2014/1016/P 10a Oakhill Avenue: Application for one large new house.

I am commenting on this application in respect of its impact on trees and biodiversity/sustainability.

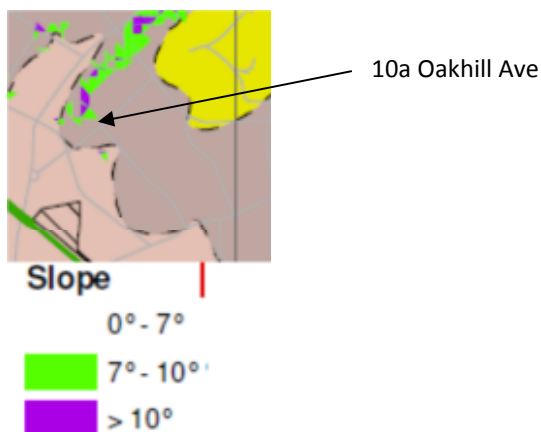
Building stability is of concern to me as when a building moves and cracks appear, for whatever reason, insurance companies and the subsidence industry will look to blame local trees. Notices of actionable nuisance are then sent out to their owners, including the local authority regarding street trees, requiring these trees to be felled. I have concerns about this development and the adequacy of the Land Stability Report:

From: BASEMENT IMPACT ASSESSMENT SCREENING REPORT: 'LAND STABILITY'  
Page 4: 'Beyond the western site boundary the ground slopes down more steeply, towards a valley of the headwaters of the River Westbourne, down which Heath Drive runs. Although the slope angle there could not be properly assessed, the Camden Slope Angle Map [Figure 16 of the Arup report] shows angles, in that vicinity, of between 7° and 10° and, locally, >10°. These slope angles are, however, outside of the site and some 20m from the existing building footprint.'

From Arup's 'Camden Geological, Hydrogeological & Hydrological Study: Figure 16 Slope angle map', it is clear that 10a Oakhill Avenue (virtually opposite Greenaway Gardens) is not far from a 7° slope, if not actually on it.

If however one turns to Figure 17 of the same Arup report: 'Landslide potential modelling of North London, British Geological Survey Internal Report, IR/03/122R; Source – British Geological Society, 1:50,000 Series England and Wales Sheet 256 – North London', it can be seen that 10a Oakhill Avenue sits right over the area of significant landslide potential. Slope angle is not the only consideration when evaluating risk of landslip, the underlying geology - including presence of ground water to lubricate slip (confirmed here) and the presence of slip surfaces left over from glacial activity during previous ice ages, relatively common within the Claygate Beds and very common within the overlying Head (unmentioned in this report) - are other important factors. These are all present or potentially present here.
